Re: Request for Additional Information

Brooksville South Cement Plant

Project No. 0530021-016-AC

**RE: *Request for Additional Information Dated 7-13-09—Response
DEP File Nos. 0530021-017-AC, 018-AC and 020-AC; Kiln 2
As-Built Configuration, Permit Extension & Trial Burning of Alternative Fuels
CEMEX Construction Materials Florida, LLC; Brooksville South Cement Plant***

Figure 2-1a. Finish Mill Process Profile, CEMEX Brooksville South; Finish Mill No. 2
 Flow Test Date: 1/15/09

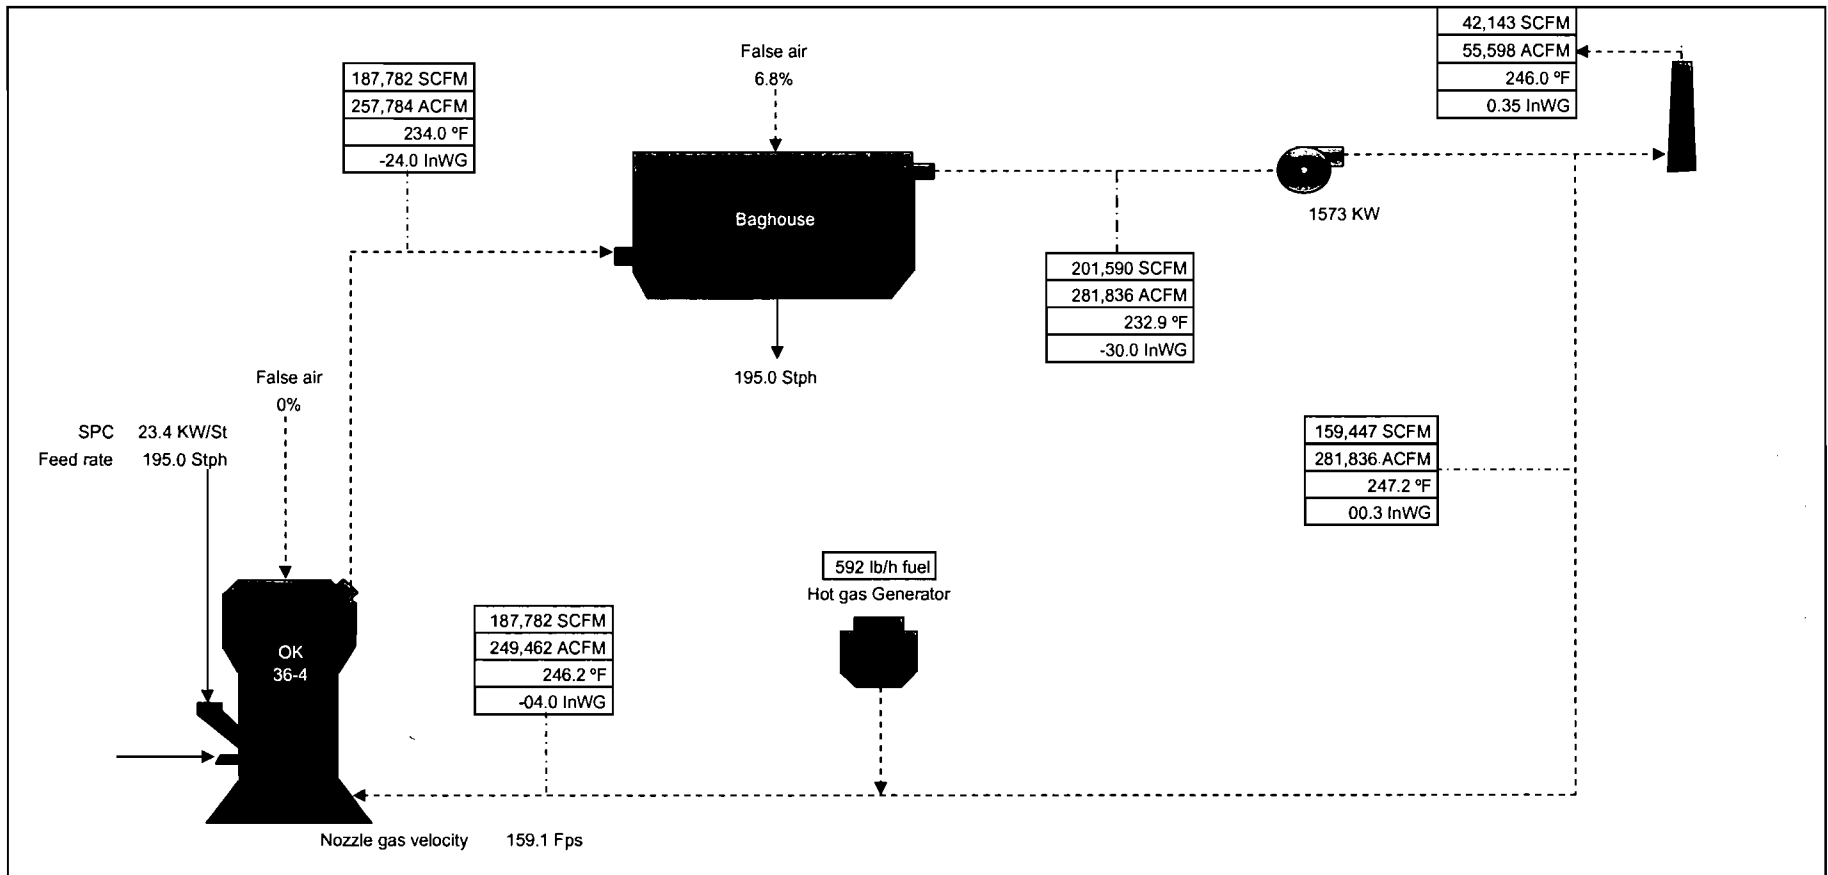
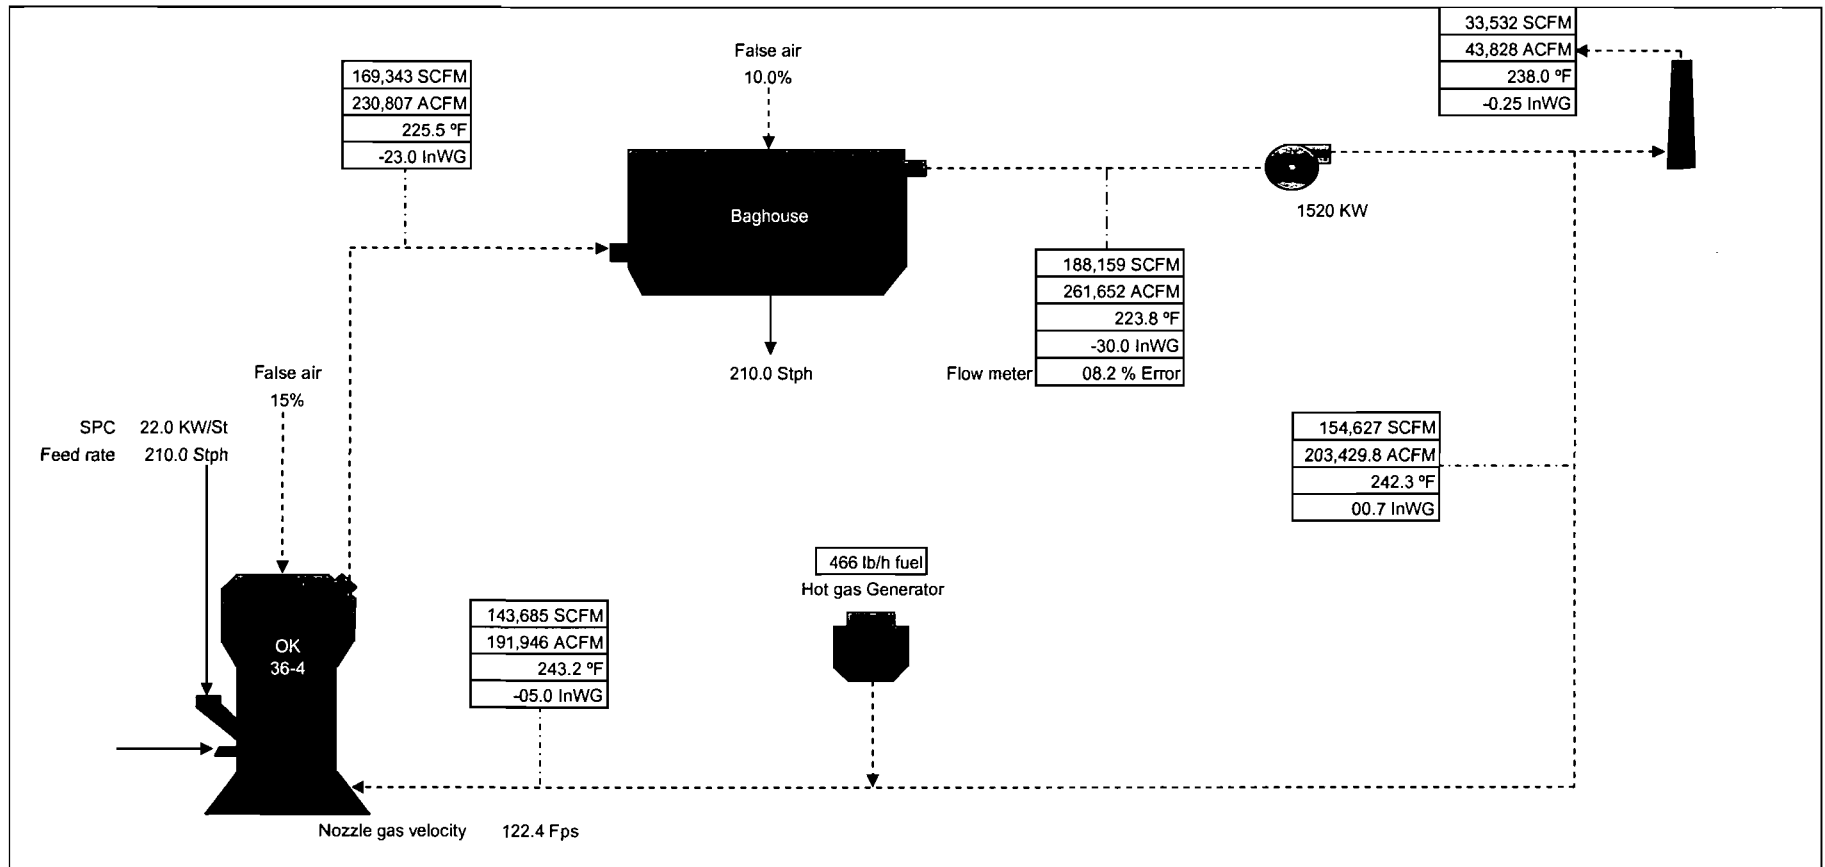
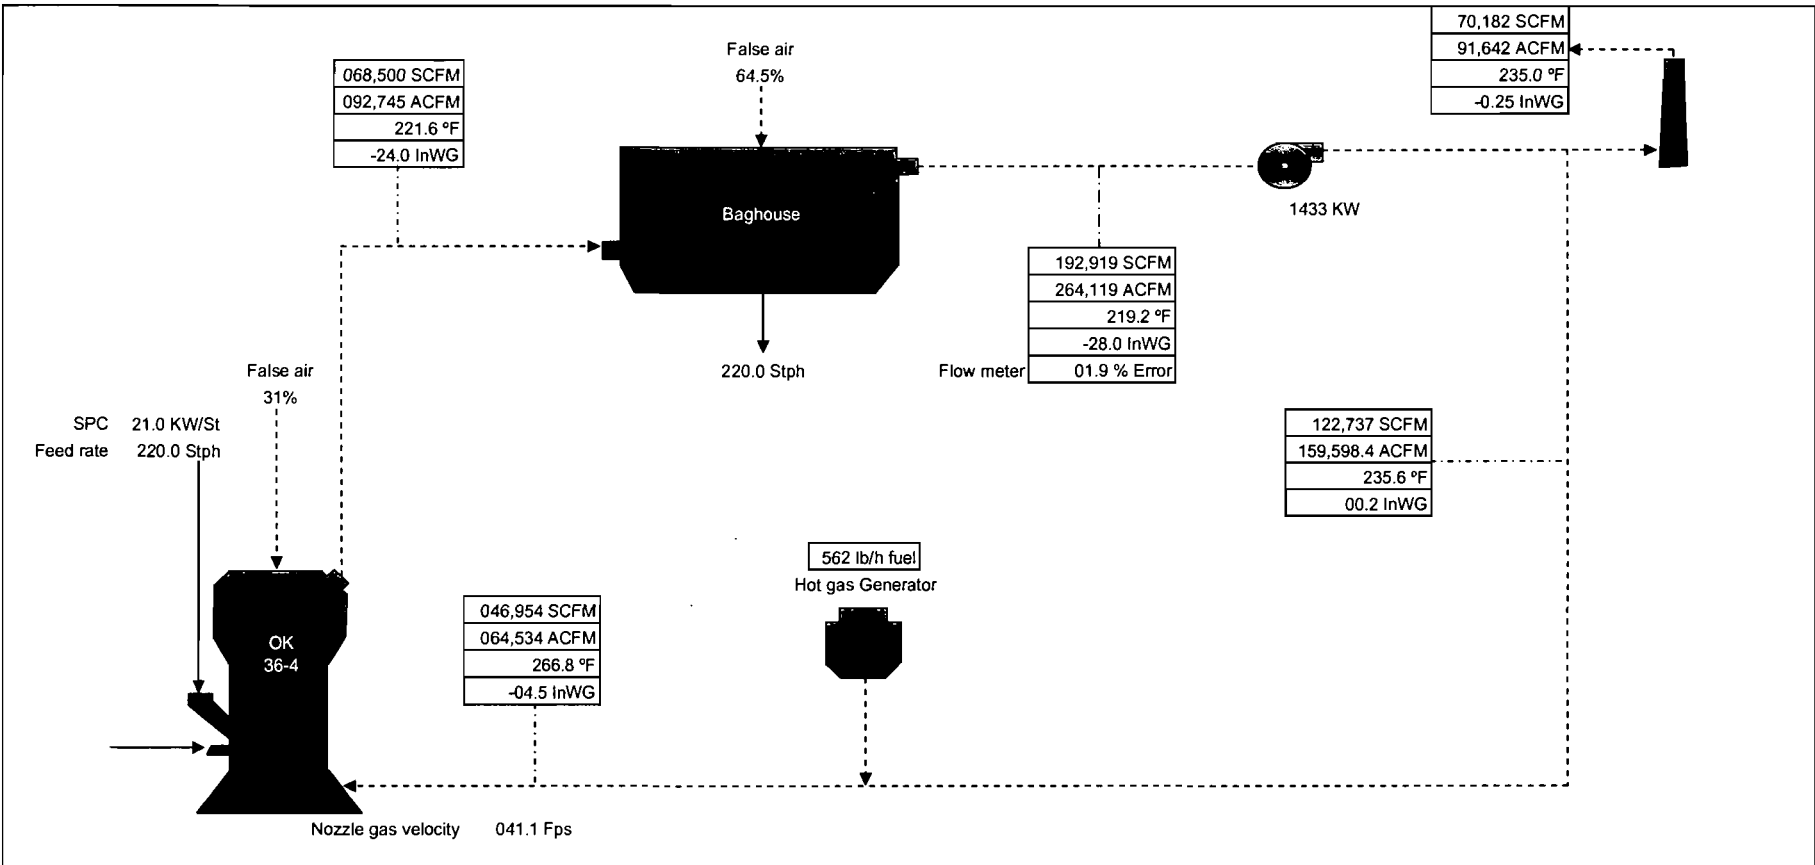
4. Finish Mill System: Note that for this emission unit (EU 052), the present particulate matter (PM/PM₁₀) emission rate limits are 2.3/1.6 pounds per hour (lb/hr) and 7.1/10.1 tons per year (TPY). The revisions requests future limits of 13.8/9.7 lb/hr and 60.5/42.4 TPY. This EU will now account for one-fourth or more of the facility's total PM/PM₁₀ emissions. Please provide the technical explanation for the increase.

Response: The original plant design included a Raw Mill with air heater and a ball mill-type Finish Mill; while the existing plant consists of a ball mill-type Raw Mill and a vertical mill Finish Mill with a hot gas air heater. The vertical mill (existing Finish Mill No. 2 design) requires more air sweep to function. However, after further review of the Finish Mill No. 2

design, it is shown (refer to Attachment 2, Figures 2-1a, 2-1b, and 2-1c) that the system recirculates a portion of the flow exiting the baghouse back through the vertical Finish Mill, while the remaining portion exits the stack. The mill was designed with new technology to save energy, in which it must use the recycled hot gases from the exit of the baghouse, heated further by the hot gas generator, for the mill to operate.

CEMEX performed some flow tests on the Finish Mill to determine how much flow was actually exiting the stack and how much was actually being diverted back to the Finish Mill. As shown in Attachment 2, Table 2-1 and Figures 2-1a, 2-1b, and 2-1c, the portion of the total baghouse flow rate exhausting the stack varied between 17% to 35%. Based on this information, and the Finish Mill design, the maximum flow rate out of the stack is estimated to be less than 100,000 dry standard cubic feet per minute (dscfm). This is conservative since this about 56% of the total baghouse exit flow rate. Although this flow of 100,000 dscfm is higher than what was measured during the flow tests, this will account for the variation in flow rates during actual operation.

The potential PM/PM₁₀ emissions that were included in the as-built modification to the construction permit (No. 0530021-009-AC/PSD-FL-351) were calculated using the maximum design flow rate of the baghouse. However, the potential PM/PM₁₀ emission rates should be based on the portion exiting the stack (a lower flow rate). Based on this, the potential PM/PM₁₀ emissions have been recalculated to be 37.5 TPY of PM and 26.3 TPY of PM₁₀ (refer also to Attachment 3 for revised application pages). As shown on revised application page number 3, the net change in emissions due to the Kiln 2 as-built system (based on revised Finish Mill flow rate) is an overall decrease in potential PM and PM₁₀ emissions by about 1.6 TPY and 1.1 TPY, respectively.
